U. S. NUCLEAR REGULATORY COMMISSION
REGION IV

NRC Inspection Report: 50-285/82-26

Facility Name: Fort Calhoun Station (FCS)

Inspection on October 25-29, 1982 (Report 50-285/82-26)

FIGURE 1

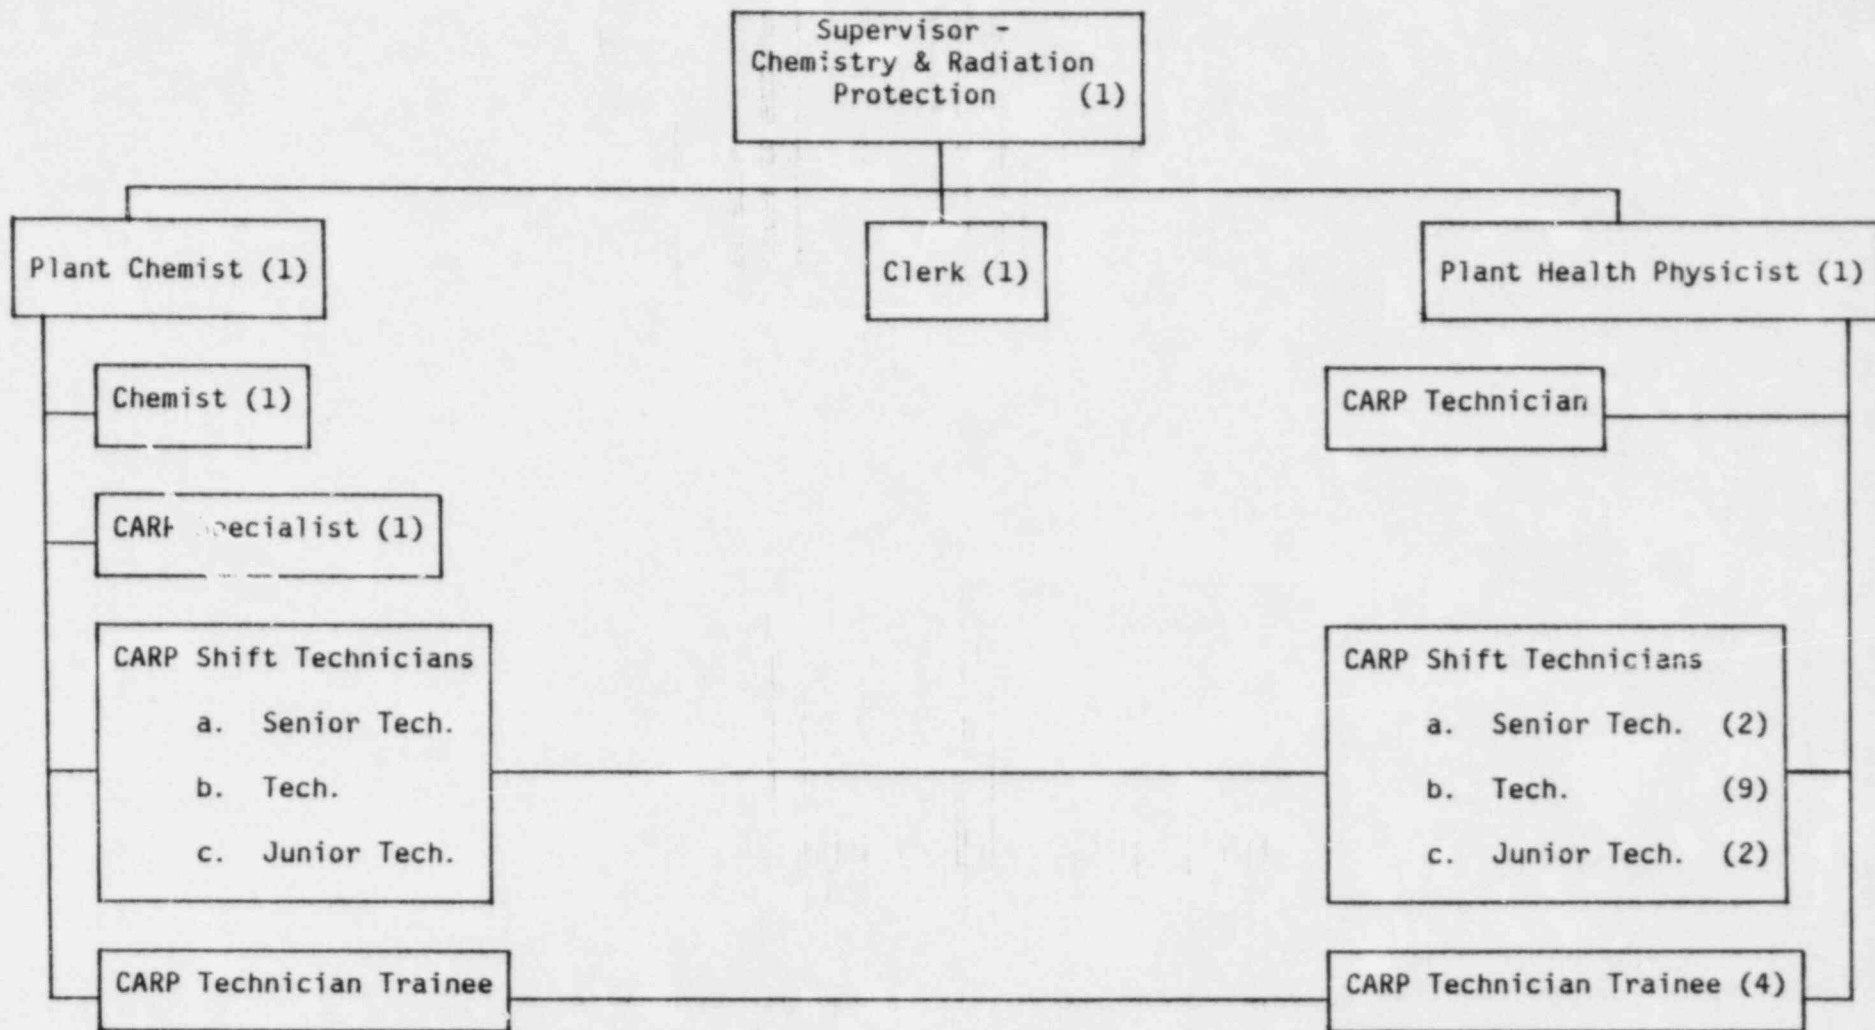
The NRC inspectors noted that the radiation protection section had not filled all authorized staffing positions and were concerned on the inordinate use of contractor health physics technicians to perform radiation protection activities during normal plant operation.
